NASIRIYAH FIRE STATION
NASIRIYAH, IRAQ

SIGIR PA-06-053
JULY 24, 2006

SUBJECT: Report on Project Assessment of the Nasiriyah Fire Station, Nasiriyah, Iraq
(Report Number SIGIR-PA-06-053)

Diagram 1. Ground floor plan showing location of exterior walls not constructed

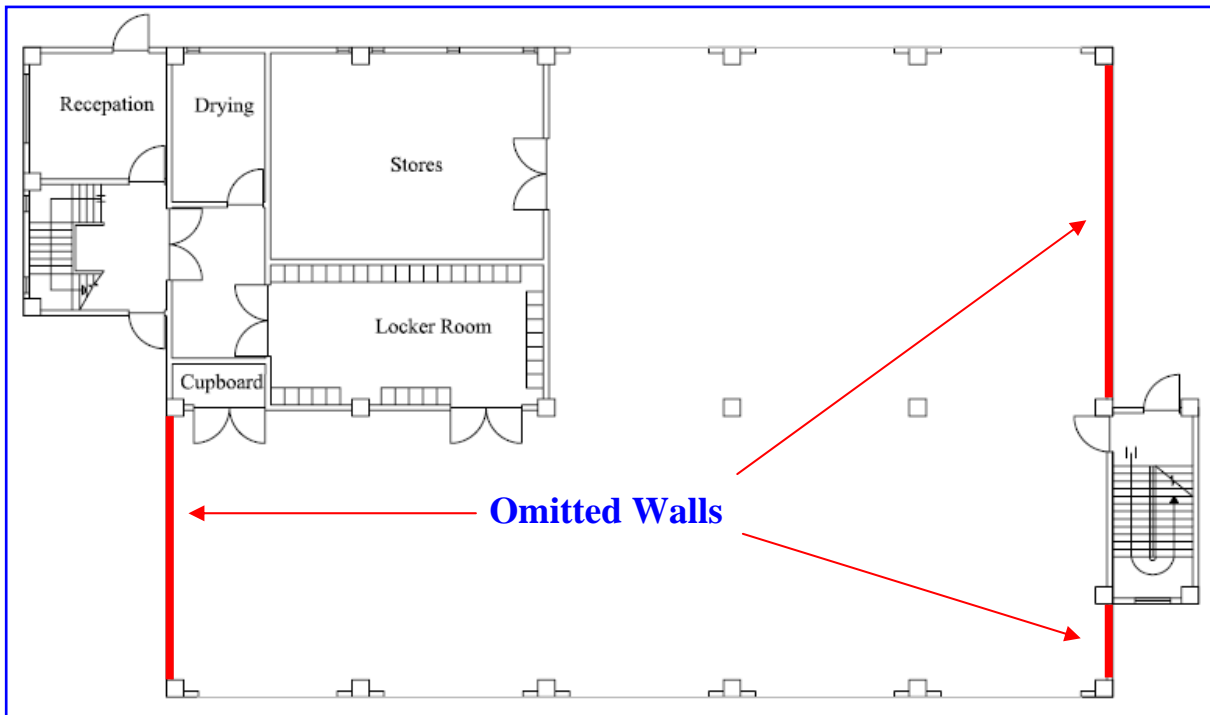
Also, the contractor failed to construct exterior walls at ground level on each side of the fire station. The USACE QAR discussed the missing non-load bearing walls with representatives of the ICDD, and the ICDD reported that the walls were not necessary. Since the walls were not load bearing, the walls were omitted from the contract requirements. The omitted walls on each side of the building are shown in Diagram 1.
